RE: Jumbo Mining Company H-10 Heap  
Leach Pad Feasibility Study  
Millard County, Utah

We have received a preliminary feasibility study on the subject project on June 12, 1991. We have reviewed this study and have the following comments for incorporation into a revised feasibility study document:

### SECTION ACROSS 6" PIPE

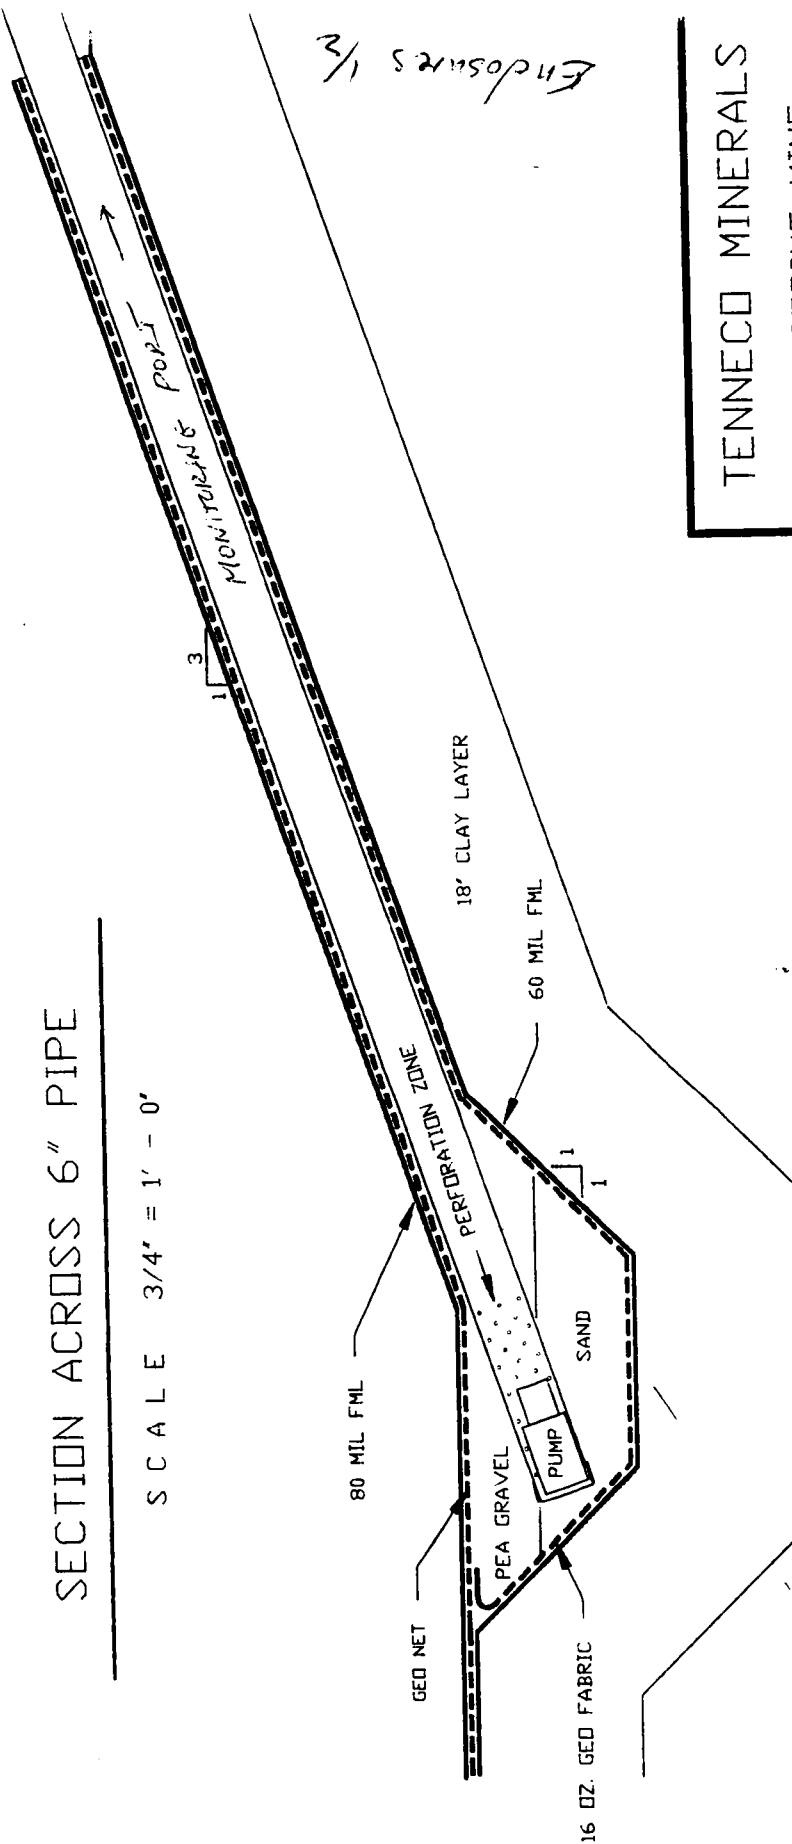
- I. Although not originally included as part of the scope of this study, the ponds for the pregnant and barren liquors will need to be replaced due to their age and outdated design. Some design examples are attached for your use.
- II. Per page 9 and 11, is the permeability expressed as the coefficient of permeability, K, in Darcy's Law,  $Q=KiA$ ?
- III. Figure 3-1 appears to have been inadvertently deleted. This figure is stated to depict soil thicknesses at the pad site. Please include.
- IV. An adequate stockpile of clay for engineered base and secondary clay liner should be assessed as to quantity and availability of such.
- V. On page 15, the flexible membrane liner (FML) is listed as 30-mil PVC. What type of cushion is to be used on top of the FML? Will the FML meet the requirements of NSF 54 with the secondary clay liner and cushion to be used?

# Double FML and Fluid Collection System

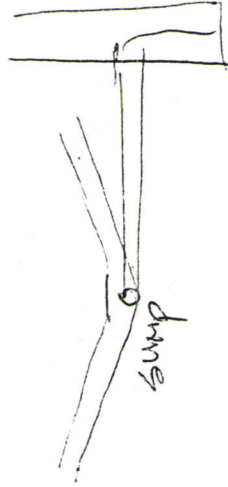
THIS CAD EXAMPLE  
SHOULD INCLUDE A  
SUMP.
